INITIAL FIRE SAFETY INSPECTION REPORT

MAS SUMANTRA 2 PRIVATE LIMITED

RSC ID: 25921

Date: 22-Jan-2025

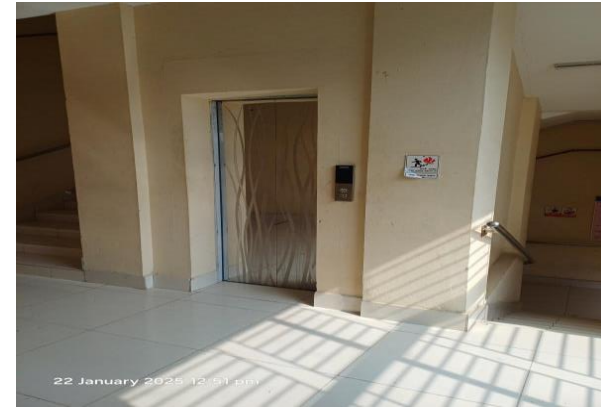
Sl No.	Category	Findings	Required Action	Remediation Time Frame
F-01	Fire Rated Construction	Female prayer room was not separated from the CMD and packing area during the inspection.	Separate the female prayer room from the CMD,Packing area as per BNBC 2006, Table 3.2.1. Seal and/or protected all openings to maintain fire separations.	Within 3 months

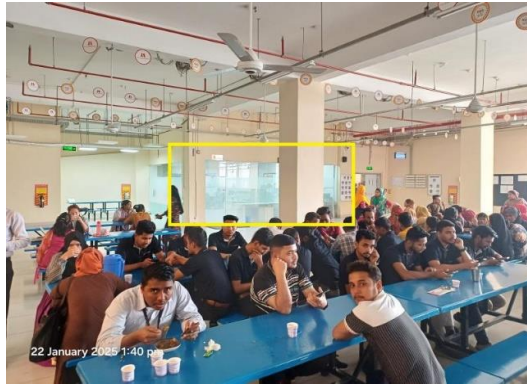
F-03	Fire Rated Construction	Dining capacity (less than 300) was not separated from the Medical room and HR office during the inspection	To classify the occupancy as E4, it's necessary to limit the occupant load to 300 or below. Afterward, ensure the fire separation from other occupancies as per BNBC 2006 table 3.2.1. Additionally, ensure that there are required direct exits available for the dining facilities, or consider relocating them to a dedicated building. .	Within 3 months
------	-------------------------	---	--	-----------------

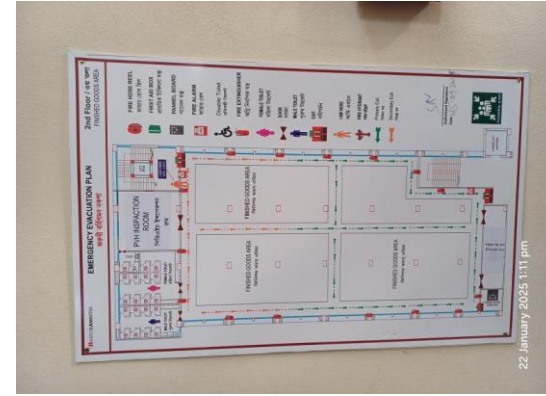
F-06	Means of Egress	The store was found to discharge directly into the exit enclosure without a vestibule at the finished goods store on the 2nd floor, the RM store on the 1st floor, and the raw material store on the ground floor	Openings from exit enclosure to storage and machine room spaces shall be provided with a vestibule with fire rated construction and openings. Provide a 1.5-hr. fire rated door on the exit stair side and a 1-hr. fire rated door on the storage and machine room side as per 6.14.3-RSC Technical Guidelines Standard V1.0. Ensure that the fire rating of the vestibule construction matches that of the exit stair enclosure. The minimum width for vestibules shall not be less than 1.1m and length 1.8m.	Within 3 months
------	-----------------	---	---	-----------------

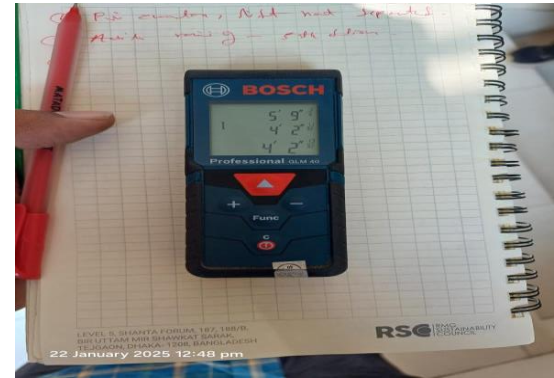
F-09	Means of Egress	The building is Interim construction and East Stair and west stair width was found less than 60 inch. East Stair (4 feet 2 inch) and west Stair (4 feet 1 inch).	Provide minimum clear and unobstructed exit stair widths of 1.5 m(60 in.) in accordance with the RSC standard 6.5.6.2.1	Within 3 months
------	-----------------	--	---	-----------------
